267 Torquay Road, Grovedale Functional Design Road Safety Audit

Prepared for Stolps Pty Ltd

11 June 2026

Reference J1342RT1948-0526

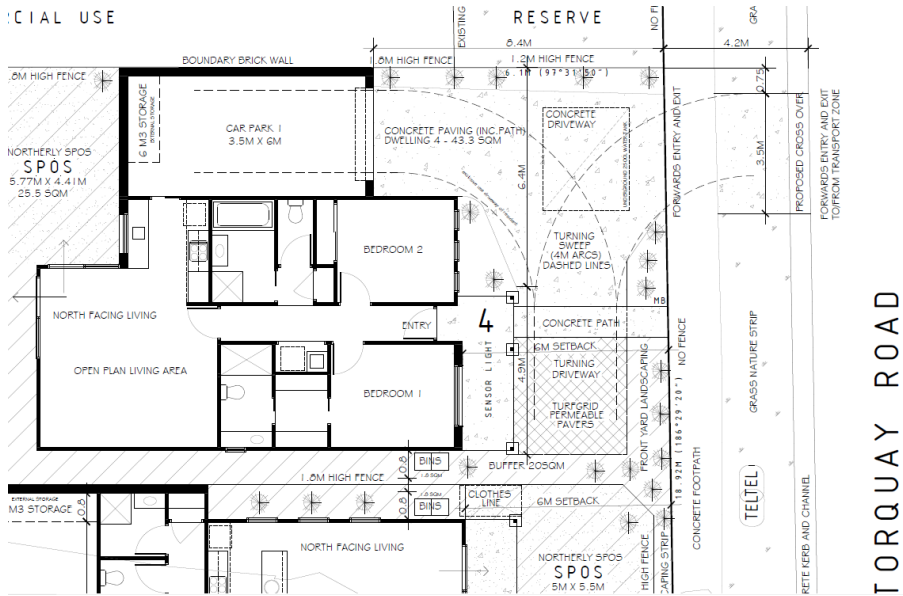
AUDIT RESULTS				PROJECT TEAM RESPONSE			RESPONSIBLE OFFICER SIGN OFF
Audit Finding Ref	Audit Finding (Risk/Hazard, Extent, Crash Type)	Risk Level	Recommendations	Acceptance Of Findings	Comments	Project Team Lead Endorsement	
Access Point - Dwelling 4	The proposed crossover serving Dwelling 4 is located approximately 25 m north of the north-western tangent point of the intersection of Torquay Road and Felix Street. Given its proximity to the intersection, vehicles entering and exiting the site may conflict with vehicles undertaking turning movements at the intersection or continuing northbound on Torquay Road, particularly during peak turning demand conditions. In addition, vegetation within the site frontage has the potential to restrict available sight distance between vehicles exiting the development, vehicles travelling along Torquay Road, and vehicles turning left from Felix Street onto Torquay Road. Any reduction in visibility at this location may increase the potential for vehicle conflict.	Likelihood: Unlikely Severity: Moderate Medium	Ensure that adequate sight distance is provided and maintained at the proposed Dwelling 4 crossover in accordance with relevant standards. Any vegetation, landscaping, fencing, or other obstructions within the vicinity of the access point should be removed, setback, or maintained to ensure unobstructed visibility for vehicles approaching along Torquay Road and for vehicles entering and exiting the site. (S)

Access Point – Dwelling 4	While the provision of an on-site turning area facilitates forward entry and forward exit movements, there remains a potential for this arrangement to be compromised in practice. For example, visitor parking on the driveway or households with more than one vehicle may result in situations where vehicles are required to reverse onto Torquay Road. At present, it is unclear how the forward entry and exit requirement would be managed or enforced to ensure ongoing compliance with the intended access arrangement. 	Likelihood: Unlikely Severity: Moderate Medium	The Dwelling 4 access and parking layout is to be improved, so far as is reasonably practicable, to ensure that vehicles can enter and exit the site in a forward direction under all reasonably foreseeable operating conditions, without reliance on behavioural or management controls. The on-site turning area is to be designed to accommodate a standard residential design vehicle (e.g. B85/B99 as applicable), with sufficient manoeuvring space provided to ensure it remains continuously usable and free of obstruction. The internal driveway and circulation layout is to be configured such that reversing movements onto Torquay Road are not required under any reasonably foreseeable operating condition. The final design is to clearly demonstrate a single, intuitive and functional vehicle path through the site. (S)

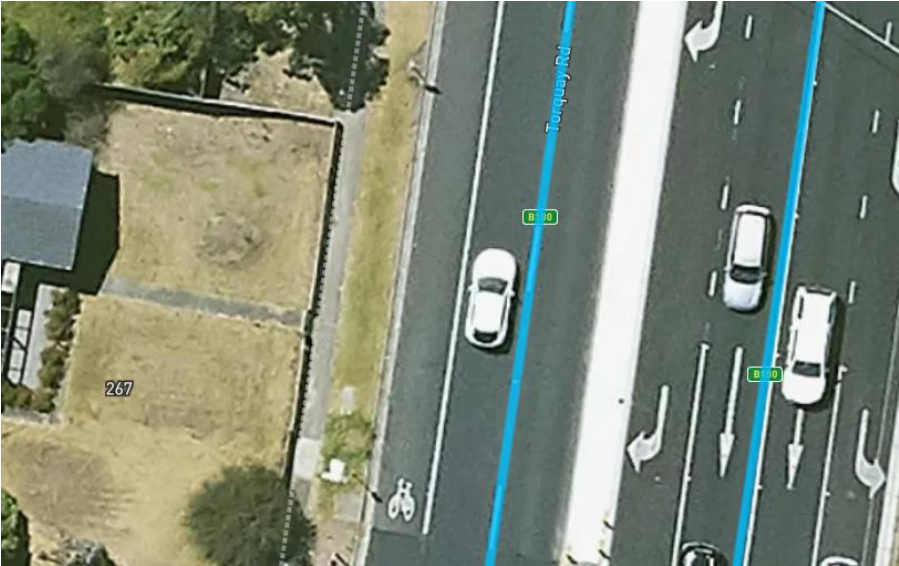
Exiting Vehicles – Dwelling 4	There is potential for unfamiliar visitors exiting Dwelling 4 to misinterpret the intended direction of travel and inadvertently turn right onto Torquay Road. This potential risk is primarily associated with visitor unfamiliarity with the site access arrangement and the surrounding road environment.	Likelihood: Rare Severity: Moderate LOW	The Dwelling 4 access arrangement is to incorporate clear directional guidance to reinforce a left-turn exit movement onto Torquay Road and minimise the potential for incorrect directional choice by unfamiliar users. This may include a directional pavement arrow provided on the internal driveway alignment at the point of decision prior to the crossover, clearly indicating the intended exit direction.

Bicycle Lane Conflict	The proposed vehicle crossover intersects an existing on-road bicycle lane on Torquay Road. The submitted plans do not clearly detail the treatment of the bicycle lane through the crossover, including how continuity, priority, and conspicuity for cyclists will be maintained at the conflict point. In the absence of a defined treatment, the interaction between entering and exiting vehicles and cyclists travelling along the bicycle lane is uncertain, particularly in relation to cyclist visibility and driver awareness at the crossing point. 	Likelihood: Rare Severity: Moderate LOW	The proposed crossover is to be designed to maintain continuity of the adjacent bicycle lane in accordance with the relevant road authority requirements. Where required by the Department of Transport and Planning, a bicycle conflict zone treatment is to be provided through the crossover, which may include green coloured surfacing and/or bicycle pavement symbols to enhance visibility and reinforce cyclist priority within the bicycle lane alignment. The final treatment is to be confirmed in consultation with the road authority. (S)

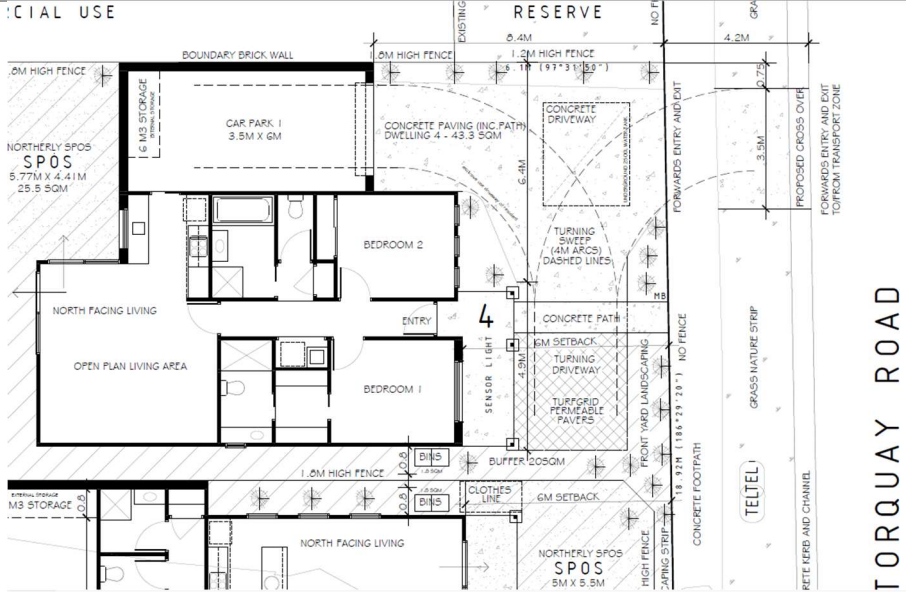
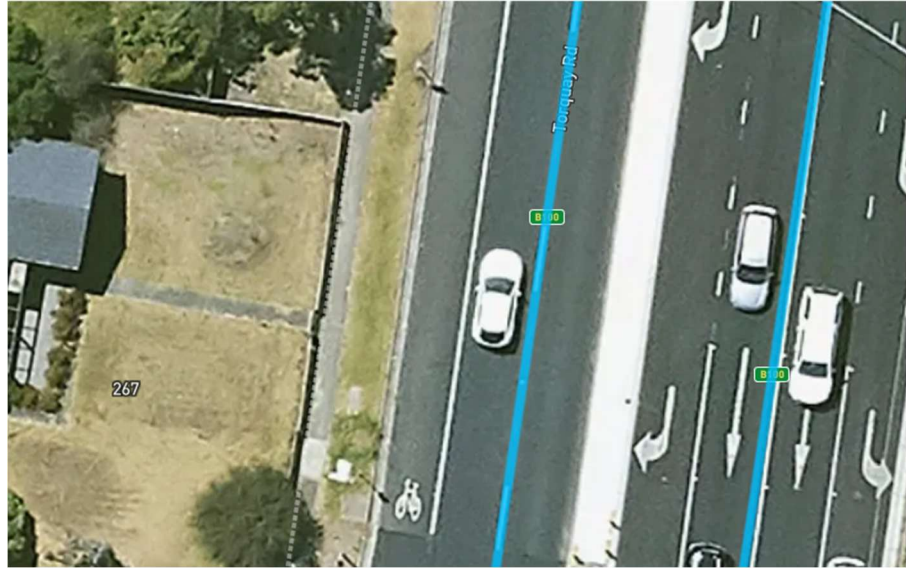
AUDIT RESULTS				PROJECT TEAM RESPONSE			RESPONSIBLE OFFICER SIGN OFF
Audit Finding Ref	Audit Finding (Risk/Hazard, Extent, Crash Type)	Risk Level	Recommendations	Acceptance Of Findings	Comments	Project Team Lead Endorsement	
Access Point - Dwelling 4	The proposed crossover serving Dwelling 4 is located approximately 25 m north of the north-western tangent point of the intersection of Torquay Road and Felix Street. Given its proximity to the intersection, vehicles entering and exiting the site may conflict with vehicles undertaking turning movements at the intersection or continuing northbound on Torquay Road, particularly during peak turning demand conditions. In addition, vegetation within the site frontage has the potential to restrict available sight distance between vehicles exiting the development, vehicles travelling along Torquay Road, and vehicles turning left from Felix Street onto Torquay Road. Any reduction in visibility at this location may increase the potential for vehicle conflict.	Likelihood: Unlikely Severity: Moderate Moderate Medium	Ensure that adequate sight distance is provided and maintained at the proposed Dwelling 4 crossover in accordance with relevant standards. Any vegetation, landscaping, fencing, or other obstructions within the vicinity of the access point should be removed, setback, or maintained to ensure unobstructed visibility for vehicles approaching along Torquay Road and for vehicles entering and exiting the site. (S)	Agree	Engaged Infra Traffic Engineers. Refer Infra Report 1/07/2026 attached No front fence proposed, low height landscaping proposed to front landscaping strip to street frontage. Refer Amended Planning Application Plans attached.

Access Point - Dwelling 4	While the provision of an on-site turning area facilitates forward entry and forward exit movements, there remains a potential for this arrangement to be compromised in practice. For example, visitor parking on the driveway or households with more than one vehicle may result in situations where vehicles are required to reverse onto Torquay Road. At present, it is unclear how the forward entry and exit requirement would be managed or enforced to ensure ongoing compliance with the intended access arrangement.	Likelihood: Unlikely Severity: Moderate Moderate Medium	The Dwelling 4 access and parking layout is to be improved, so far as is reasonably practicable, to ensure that vehicles can enter and exit the site in a forward direction under all reasonably foreseeable operating conditions, without reliance on behavioural or management controls. The on-site turning area is to be designed to accommodate a standard residential design	Agree	Engaged Infra Traffic Engineers. Refer Infra Report 1/07/2026 attached. The sweep paths have be designed to meet the

Turning Area – Dwelling 4	Based on the provided Town Planning (TP) drawings, only indicative turning radii have been shown and no swept path assessment has been provided to demonstrate the functionality of the proposed on-site turnaround area. Accordingly, the ability of the turnaround area to accommodate both B85 and B99 design vehicles while maintaining the intended forward entry and forward exit operation has not been demonstrated. In the absence of swept path analysis, the operational performance of the turnaround arrangement remains unverified, with the potential for reversing movements to be required within or from the site, should the design not function as intended.	Likelihood: Unlikely Severity: Moderate Moderate Medium	A swept path assessment is to be undertaken and provided for the proposed on-site turnaround area demonstrating its ability to accommodate both B85 and B99 design vehicles. Should the swept path assessment demonstrate that the intended operation cannot be achieved, the internal layout is to be revised to ensure adequate manoeuvring space is provided to avoid the need for reversing movements within or onto Torquay Road. (S).	Agree	Engaged Infra Traffic Engineers. Refer Infra Report 1/07/2026 attached. Sweep paths have been demonstrated to function within the site and provide forwards entry and exit from

vehicle (e.g. B85/B99 as applicable), with sufficient manoeuvring space provided to ensure it remains continuously usable and free of obstruction. The internal driveway and circulation layout is to be configured such that reversing movements onto Torquay Road are not required under any reasonably foreseeable operating condition. The final design is to clearly demonstrate a single, intuitive and functional vehicle path through the site. (S)		requirement recommendations. Refer Amended Planning Application Plans attached.	
Exiting Vehicles – Dwelling 4	There is potential for unfamiliar visitors exiting Dwelling 4 to misinterpret the intended direction of travel and inadvertently turn right onto Torquay Road. This potential risk is primarily associated with visitor unfamiliarity with the site access arrangement and the surrounding road environment.	Likelihood: Rare Severity: Moderate Moderate LOW	The Dwelling 4 access arrangement is to incorporate clear directional guidance to reinforce a left-turn exit movement onto Torquay Road and minimise the potential for incorrect directional choice by unfamiliar users. This may include a directional pavement arrow provided on the internal driveway alignment at the point of decision prior to the crossover, clearly indicating the intended exit direction. Where practicable, supplementary advisory signage (e.g. “Left Turn Exit Only” or equivalent directional advisory sign) may be installed within the private access domain in a highly conspicuous location at the decision point to reinforce the intended movement. (S)	Agree	The applicant and owner agree to implement any conditions of permit to include any requested method of signage, driveway markings within the private domain deemed necessary by the road authority.

Torquay Rd. Also Refer Amended Planning Application Plans matching Infra sweep path compliance designs attached.		
Bicycle Lane Conflict	The proposed vehicle crossover intersects an existing on-road bicycle lane on Torquay Road. The submitted plans do not clearly detail the treatment of the bicycle lane through the crossover, including how continuity, priority, and conspicuity for cyclists will be maintained at the conflict point. In the absence of a defined treatment, the interaction between entering and exiting vehicles and cyclists travelling along the bicycle lane is uncertain, particularly in relation to cyclist visibility and driver awareness at the crossing point. 	Likelihood: Rare Severity: Moderate LOW	The proposed crossover is to be designed to maintain continuity of the adjacent bicycle lane in accordance with the relevant road authority requirements. Where required by the Department of Transport and Planning, a bicycle conflict zone treatment is to be provided through the crossover, which may include green coloured surfacing and/or bicycle pavement symbols to enhance visibility and reinforce cyclist priority within the bicycle lane alignment. The final treatment is to be confirmed in consultation with the road authority. (S)	Agree	The Applicant and Owner agree to any conditions of permit requirement for the cross over to maintain continuity of a bicycle lane deemed necessary for the site development by the road authority.
